# AD 313: Precast concrete floors in steel framed buildings: Achieving floor diaphragm action and acoustic performance

The purpose of this AD note is to highlight the existence of the new acoustic details for precast concrete separating floors in steel-framed buildings that are provided in Section 4.3 of SCI publication P351, *Precast concrete floors in steel framed buildings*. These new details enable floor diaphragm action to be achieved while also providing a detail that will satisfy the acoustic requirements for residential buildings.

Figure 1: Junction detail without diaphragm action

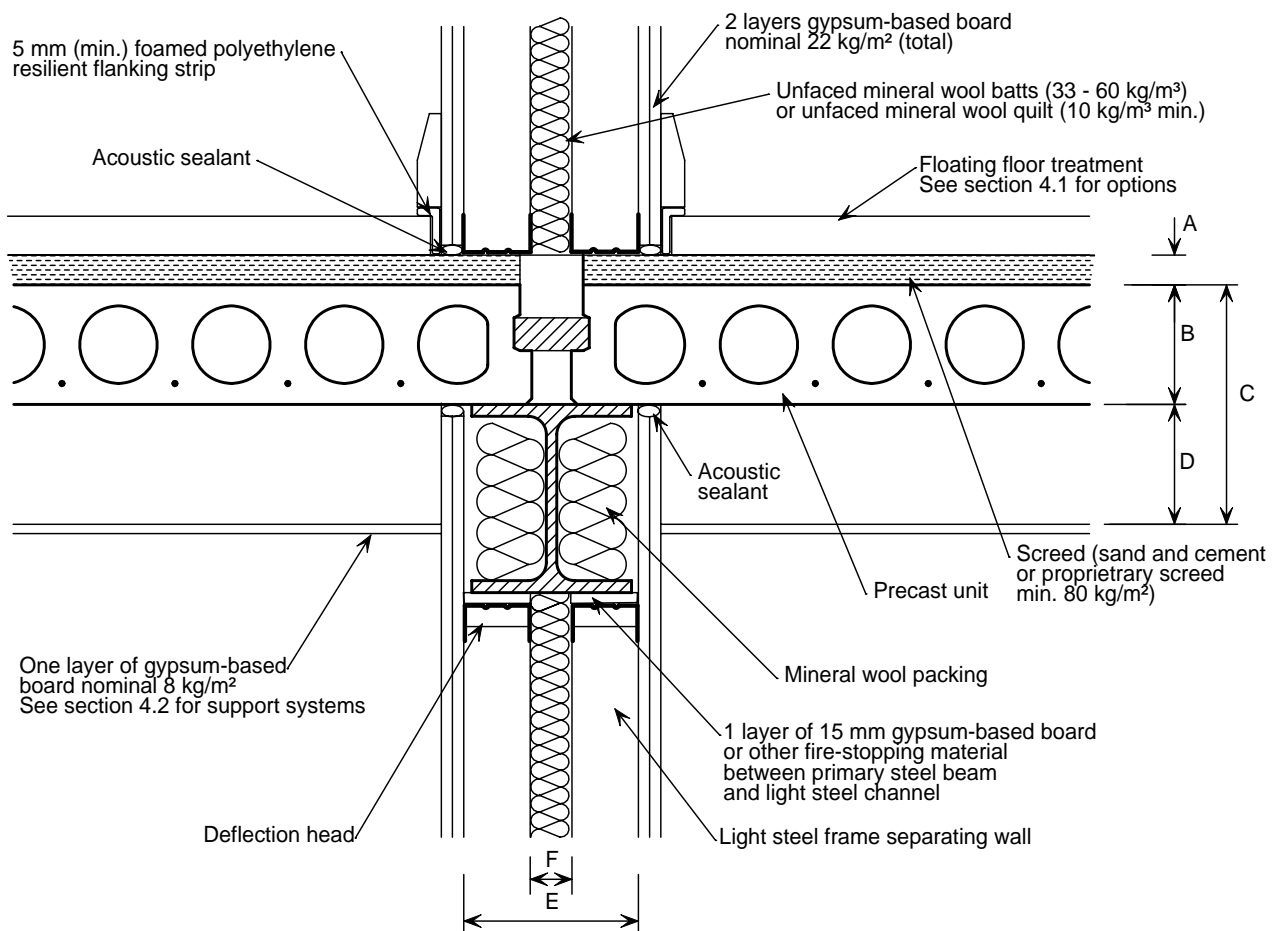
Prior to the publication of P351 the only acoustic detailing guidance for precast concrete separating floors in steel framed buildings was in Section 3 of P336. However, the details shown in P336 do not provide floor diaphragm because no grout or concrete is shown between the precast units at the location of a separating wall junction (for example, see Detail 3.2.1 in P336, reproduced here as Figure 1). Use of this detail where floor diaphragm action is relied upon in structural design to transfer horizontal loads (a common situation) is potentially dangerous.

**Figure 2:** Junction detail that provides diaphragm action

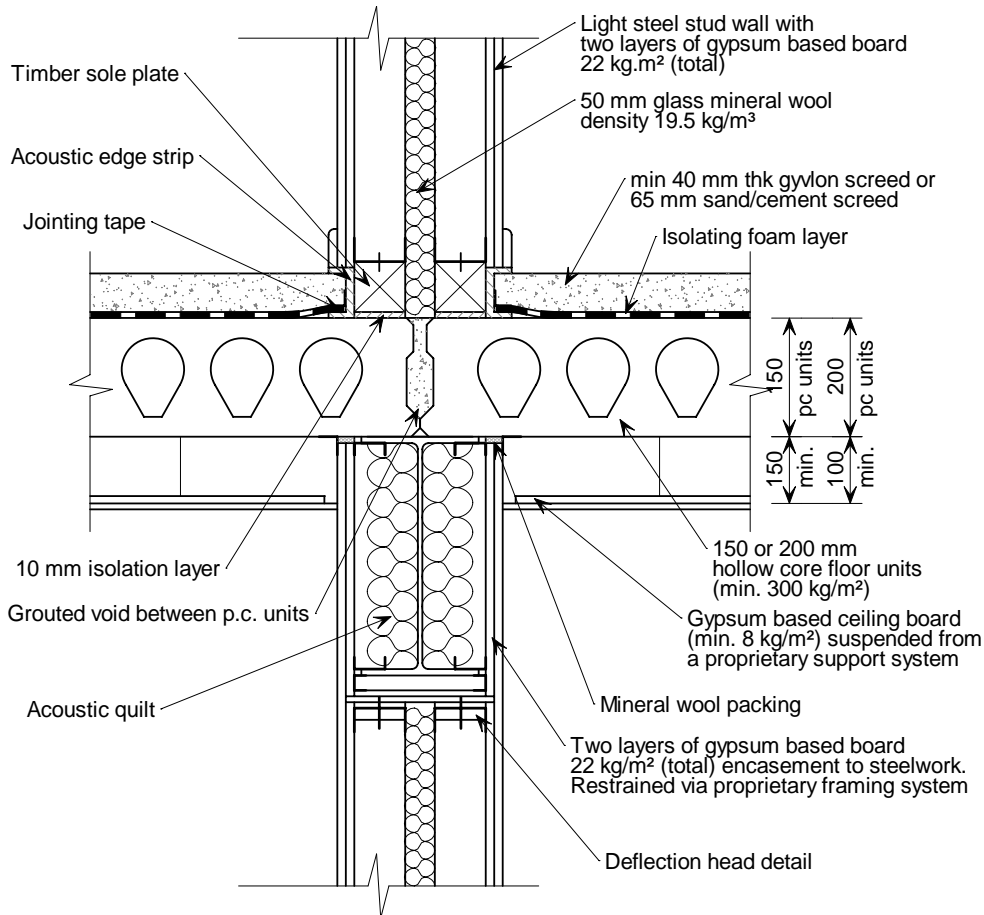
To provide floor diaphragm action, grout should be placed between the precast units, as shown in P351 (for example see Figure 4.20, reproduced here as Figure 2) and such details have been proved by on-site testing to meet the acoustic requirements. Section 2.6 of P351 provides comprehensive guidance on how to ensure diaphragm action is provided with a precast concrete floor.

The acoustic details shown in both P336 and P351 provide the necessary acoustic performance for residential buildings but only the details in P351 also provide floor diaphragm action.
